## SERVICE ACTION

<b>Reference number:</b>	SA-07-1184	<b>Issued:</b> 23 November, 2018
<b>Subject:</b>	Extension for Differential Breather Pipe	
<b>Model(s):</b>	Vantage (19MY)	
<b>VIN Range:</b>	Refer to the separately published list of affected Vehicle Identification Numbers (VINs)	
<b>Applicable to:</b>	All Dealers	
<b>Distribute to:</b>	After Sales Manager Executive Manager Service Manager Sales Manager	Warranty Staff Technician(s) Parts Staff

Figure 1

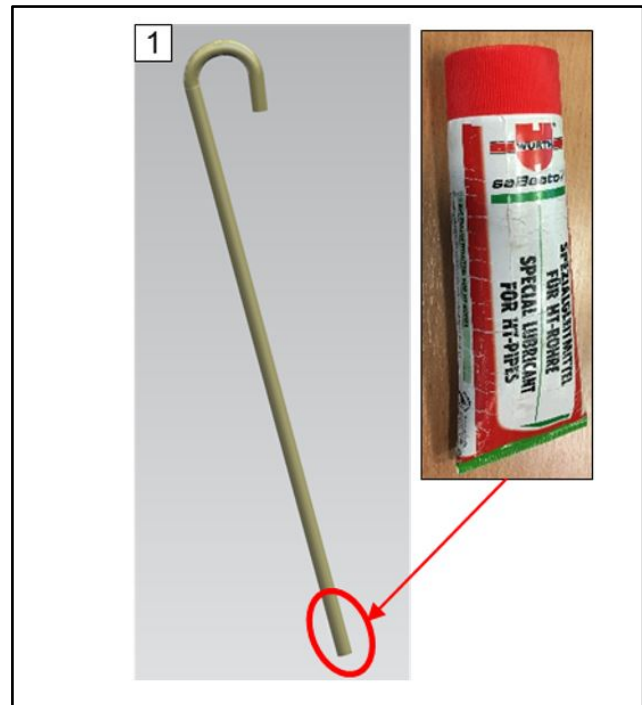
1. Remove the rear right side wheel-arch liner (refer to Workshop Manual procedure 01.08.AK).
2. Apply a small quantity of lubricant suitable for high temperature applications to the differential breather pipe extension (refer to Figure 1).

Figure 2

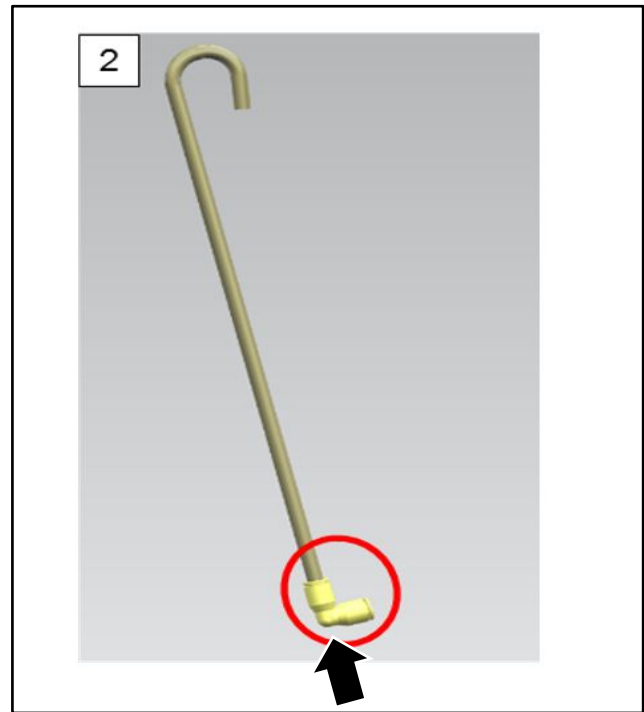
3. Install the 8mm to 8mm elbow joint to the extension for the differential breather pipe (refer to Figure 2).

Figure 5

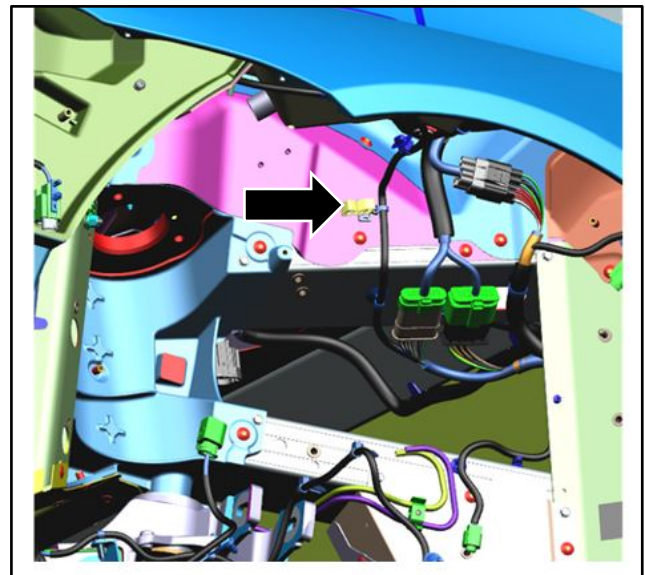
6. Install the clip to the vehicle body (refer to Figure 5).

Figure 6

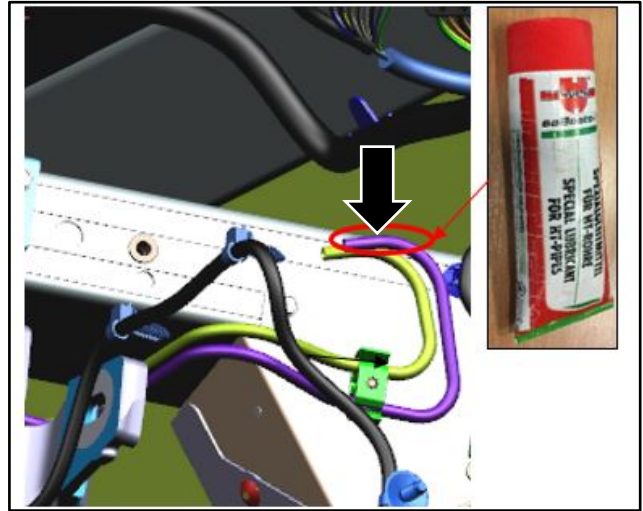
7. Apply a small quantity of lubricant suitable for high temperature applications to the differential breather pipe (refer to Figure 6).

Figure 7

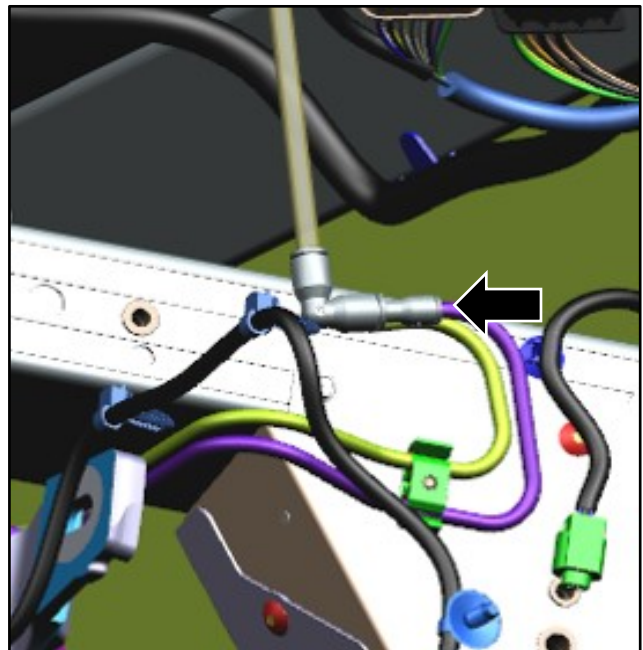
8. Install the differential breather pipe to the extension assembly for the differential pipe (refer to Figure 7).

Figure 8

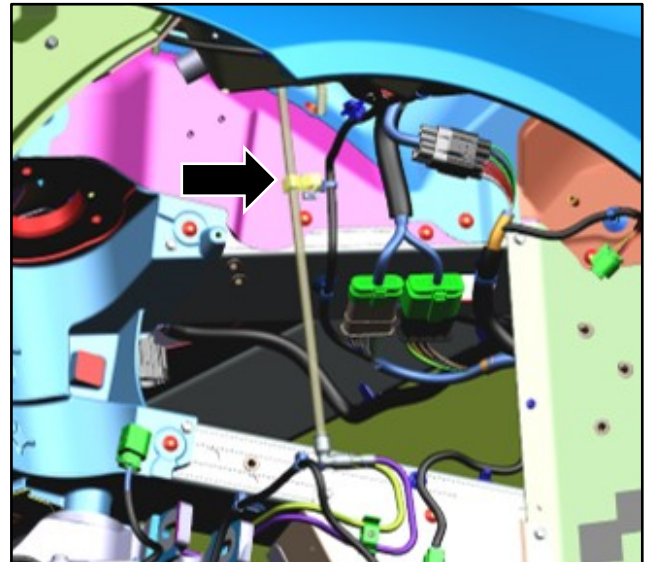
9. Install the extension assembly for the differential breather pipe into the body clip (refer to Figure 8).
